CITY OF OPELIKA
HISTORIC PRESERVATION COMMISSION
March 12, 2026
4:30 p.m.
Meeting Chambers at Opelika Municipal Courtroom
300 MLK Boulevard

1. 1100 3rd Ave: Northside Historic District
COA: Porch railings, Decking, and Gutter
Applicant: Michelle Johnson

City of Opelika
Historic Preservation Commission
Staff Report

Agenda Item #: 1
Meeting Date: 03/12/2026
Action Requested: Retroactive COA: Porch railings, Decking, and Gutters
Location of Property: 1100 3rd Ave; Northside Historic District
Petitioner: Michelle Johnson

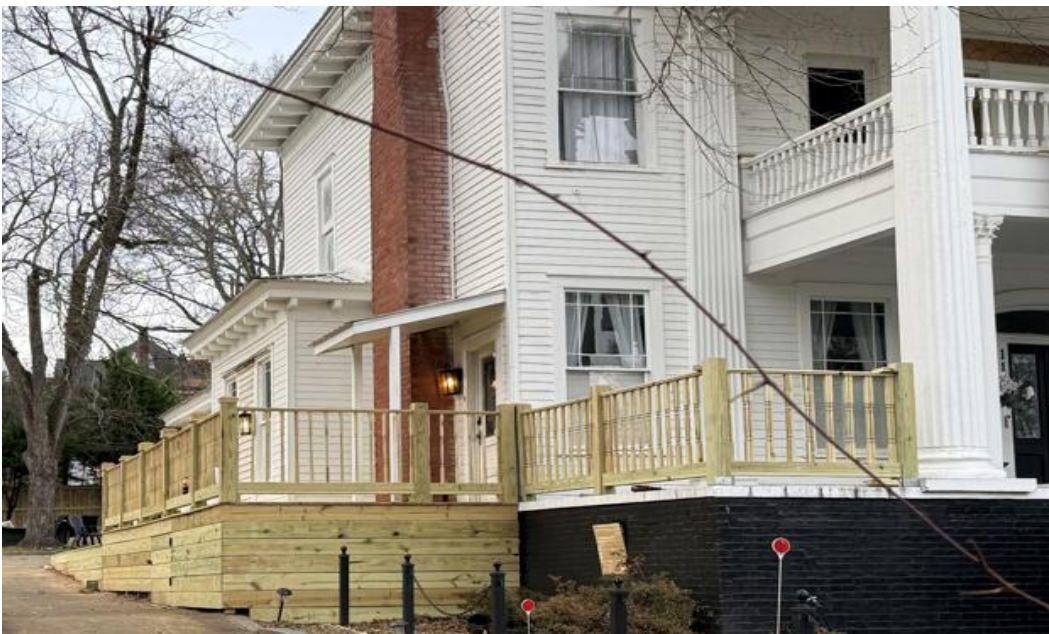
1. Install new railing on the first floor and replace railing on the top floor to match the design of the original railing.
2. Install 10' x 60' side deck to allow exit from side door.
3. Replace back porch decking and extend porch. Add rail to match the side deck.
4. Install metal gutter on carport to divert water from structure.

1. Staff recommends approval of replacing the upper floor railings and installing a new railing on the first floor with wood spindles and posts closely matching the original design.
2. Staff recommends approval of 10' x 60' side deck with ramp to allow for accessible accommodation. However, Staff recommends spindles either match the front porch or be a less decorative square design that does not compete with the spindles on the front.
3. Staff recommends replacement of back porch decking and extending the porch to include wood railing and spindles matching the side deck.
4. Staff recommends approval of metal gutters on the carport to divert water away from structure.
